# Work Order ID 87155

Item Name: Crosstube Turning Detail

DRAWING NO. D412-664-243	TITLE CROSSTUBE ASSEMBLY (412 HI AFT)	REV. E	DART AEROSPACE LTD ENGINEERING ORDER		D.E.O. NO. D412-664-243-E-1	SHEET NO. SHEET 1 OF 2	SCALE NTS
DRAWN	CHECKED <i>MP</i>	MFG. APPR. <i>E</i>	APPROVED <i>MP</i>		DE APPR. <i>MP</i>		
DATE 11.03.31	DATE 11/03/31	DATE 11.03.31	DATE 11/03/31		DATE 11.03.31

REMOVED ABRASION STRIP IN FAVOR OF A THIN LAYER OF PROSEAL 890.

**D412-664-243  
ASSEMBLY DETAIL**

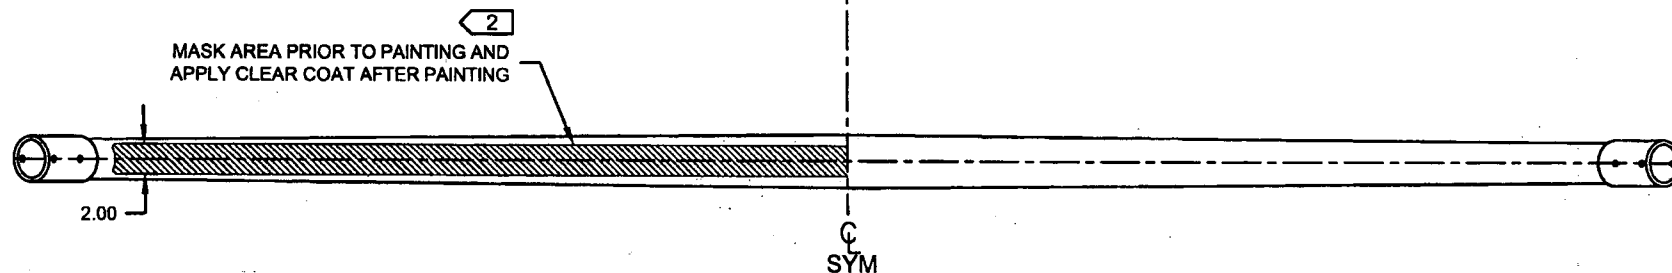
**IS:**

D3189-1 CHAFING SHIELD (1, INSTALLED OVER PROSEAL 890)  
MS21920-28 CLAMP, 2X  
2 PL

**WAS:**

D2856-600-1009 ABRASION STRIP  
D3189-1 CHAFING SHIELD (1, INSTALLED OVER ABRASION STRIP)  
MS21920-28 CLAMP, 2X  
2 PL
